## ADDENDUM No. 3

### RFP No. 22-76

#### East Medical Center Drive Bridge Rehabilitation and Widening Project

**BOLTED REPAIR ELEVATION - B1**  
(BOLT HOLES IN END DIAPHRAGM CONNECTION PLATES NOT SHOWN)

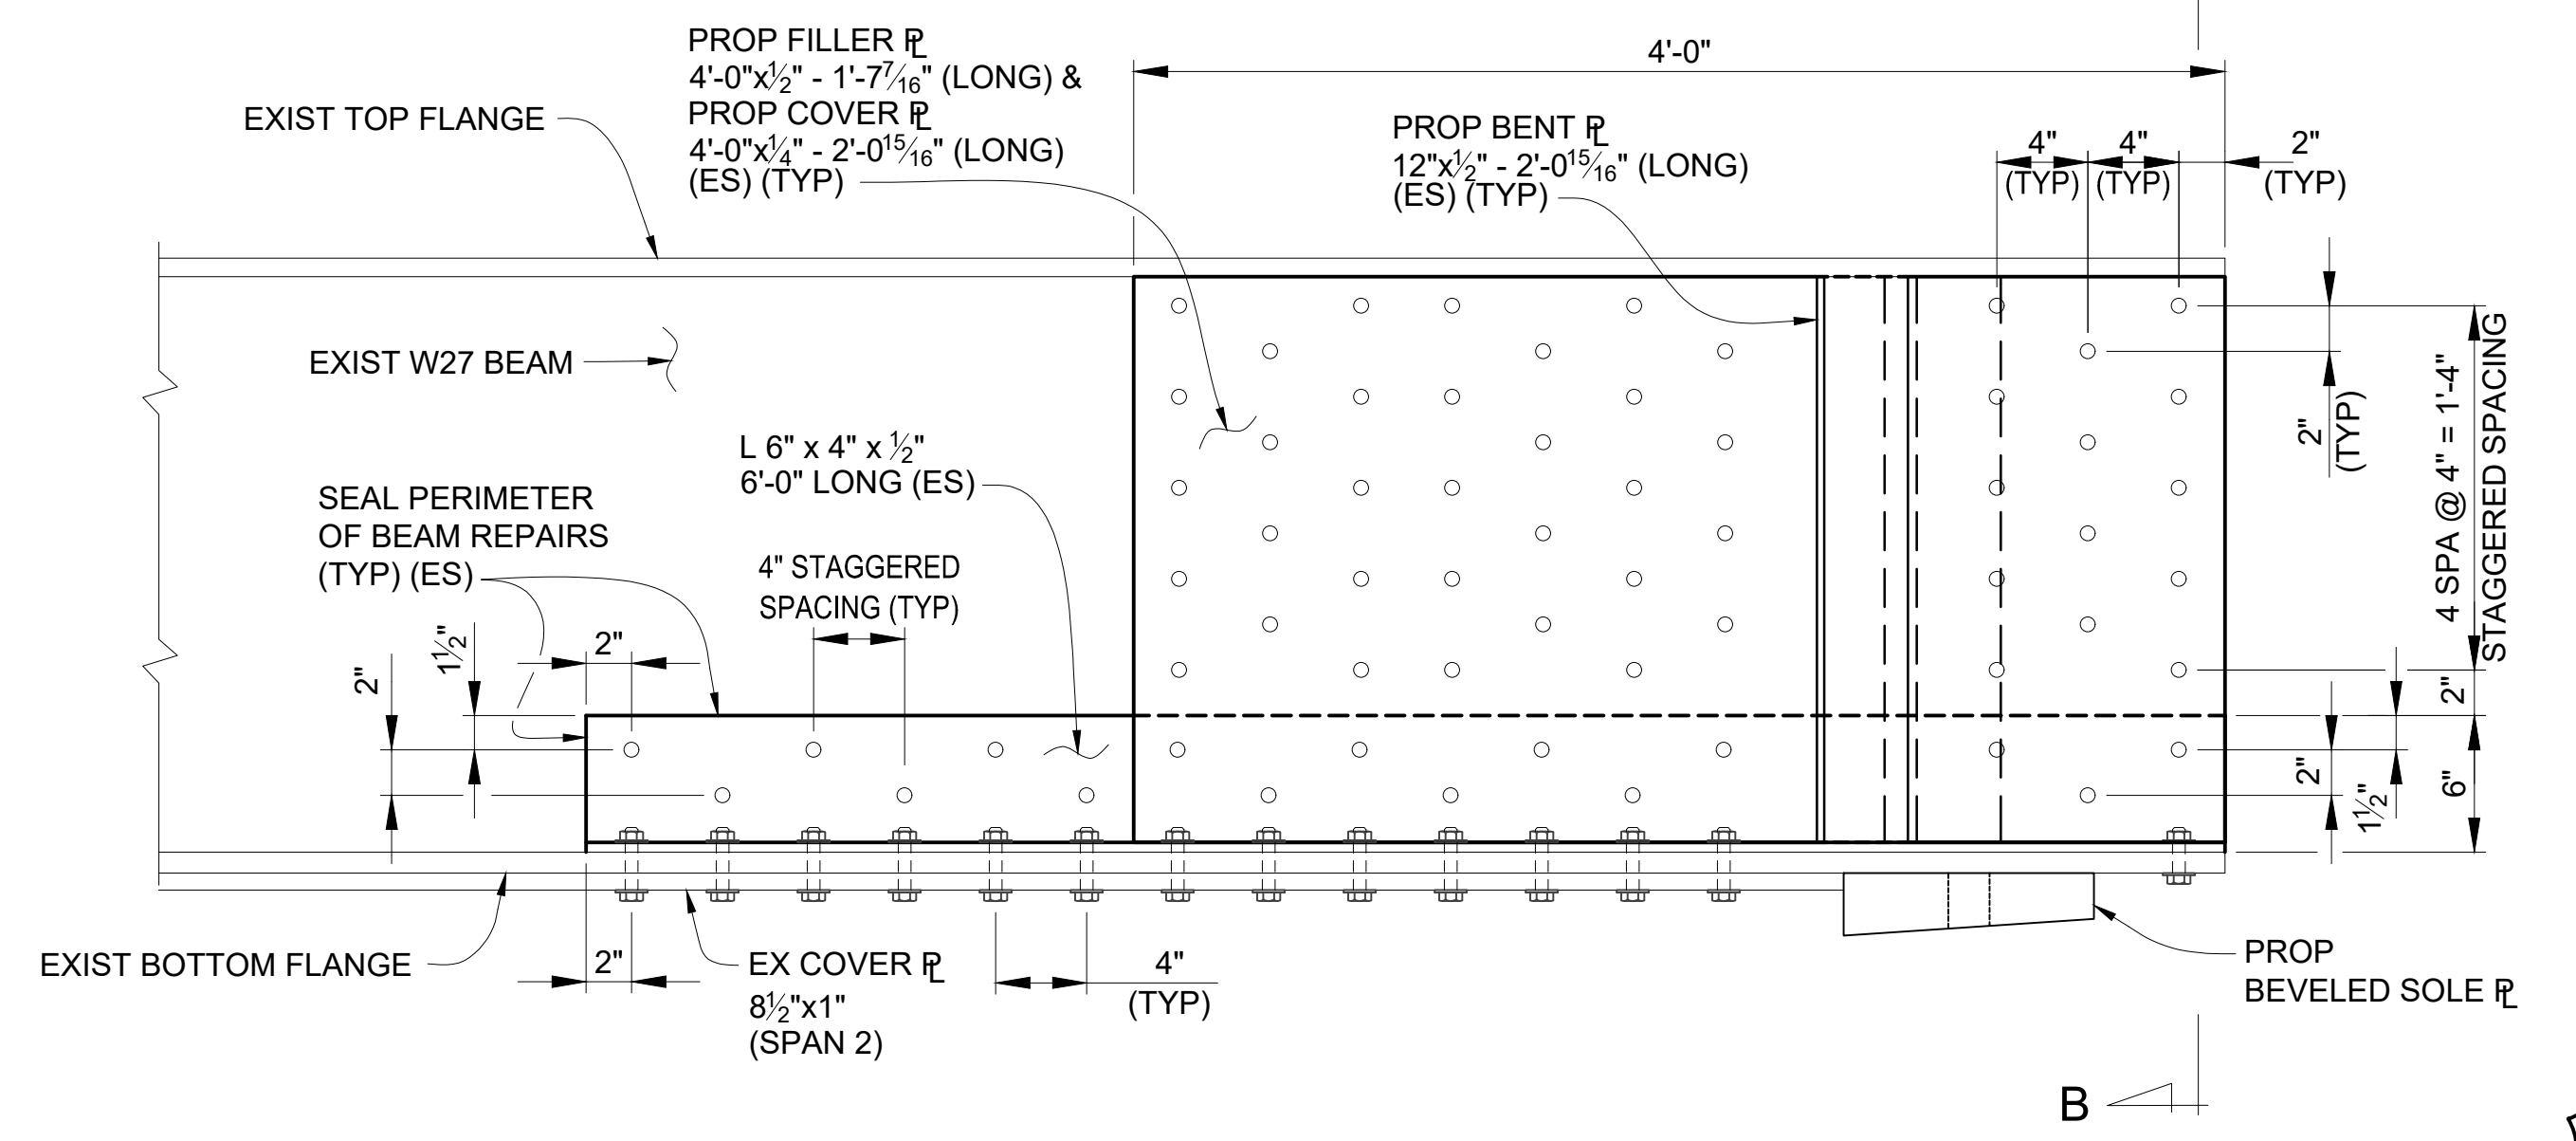
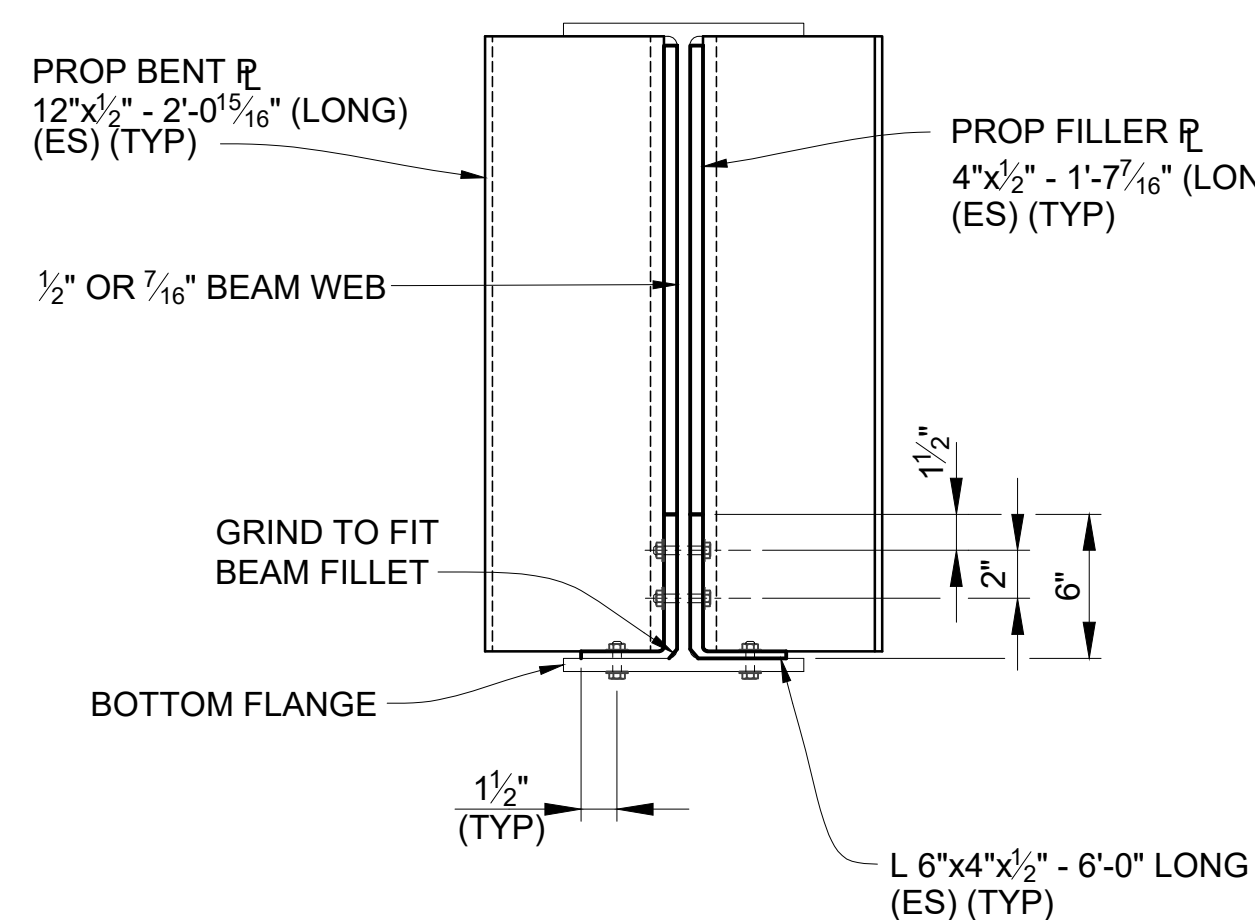
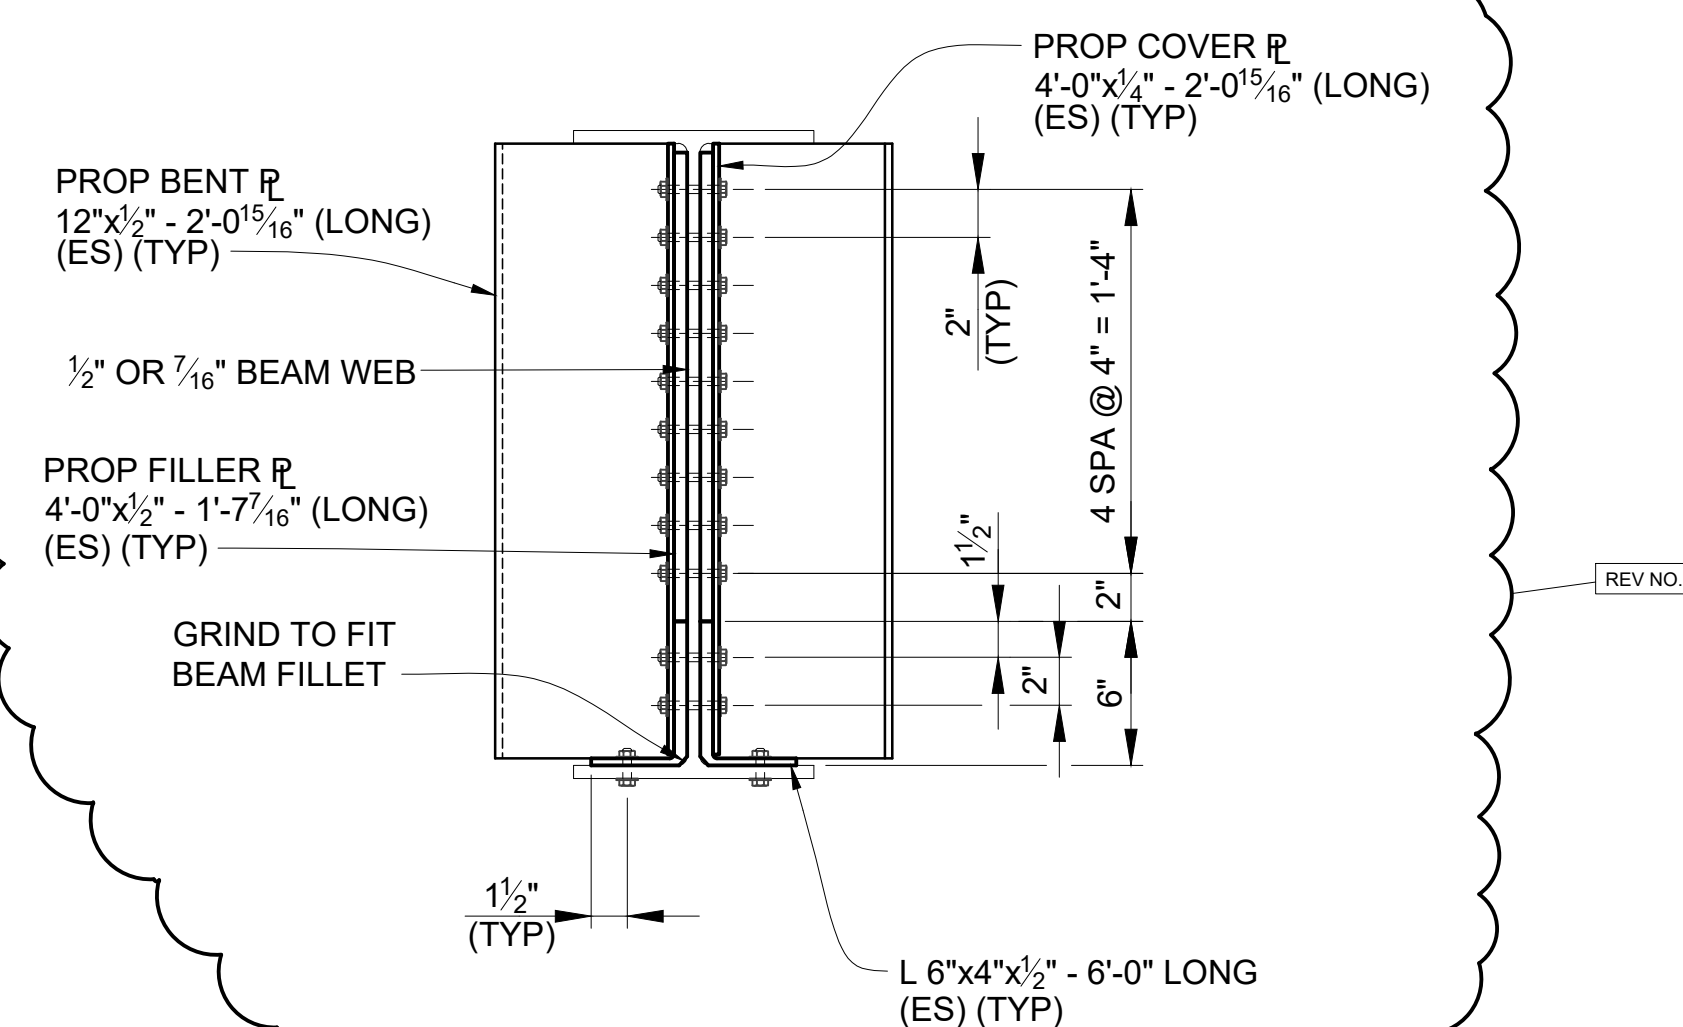
RFP_22-76_Plans Sheet 99	The bolted repair details have been updated based on the results of the October 2022 bridge inspection.
RFP_22-76_Plans Sheet 104	Barrier post spacings in the Span 1, west sidewalk were shifted to make room for chain link fence posts around the light standard.
RFP_22-76_Plans Sheet 105	The cross-sections were updated to show a proposed chain link fence on top of the barrier.
RFP_22-76_Plans Sheet 106	The cross-section was updated to show a proposed chain link fence on top of the barrier.
RFP_22-76_Plans Sheet 109	The splashboard panel spacing was replaced with chain link fence post spacing.
RFP_22-76_Plans Sheet 110	The splashboard panels are being deleted from the plans.
RFP_22-76_Plans Sheet 111	<p>A note was added to the plans to provide direction for the proposed fencing.</p> <p>A pay item for "Elec Grounding System" with a quantity of 1 Ea was added to the plan sheet.</p> <p>A pay item for "Fence, Structure" with a quantity of 2,635 Sft was added to the plan sheet.</p>
